Type of Survey Hydrographic
Field No. ECEP-1653 Office No. H-8093

State New Hampshire
General locality Portsmouth
Locality Great Bay & Squamscott River

REVIEW OF HYDROGRAPHIC SURVEY

REGISTRY NO. H-8093

Chart - 229

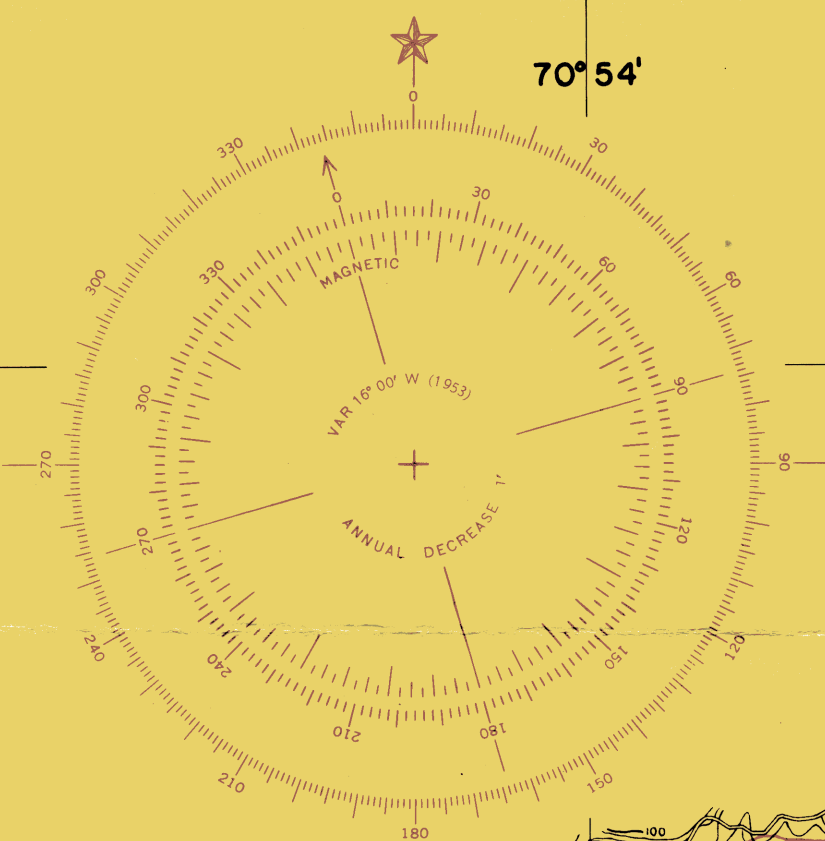
The rock awash charted in lat. $43^{\circ}04.78'$, long. $70^{\circ}51.75'$, from advance print of T-8531 (1943) should be disregarded. T-8531 does not now show the rock nor does T-11143 (1951-54). Although the present survey reveals no rock in the above position, it does however, locate a rock pile about 180 meters southwestward which should be charted.

The charted clearance of the swing bridges in lat. $43^{\circ}02.35'$, long. $70^{\circ}55.73'$, and lat. $43^{\circ}03.15'$, long. $70^{\circ}54.75'$, originate with the Corps of Engineers' Bridge Book and information furnished in Chart Letter 405 (1950), respectively. No information pertaining to the clearances was obtained on the present survey.

The buoy charted in lat. $43^{\circ}04.41'$, long. $70^{\circ}52.26'$, was located about 110 meters northeastward on the present survey. The charted buoy appears to serve the purpose intended.
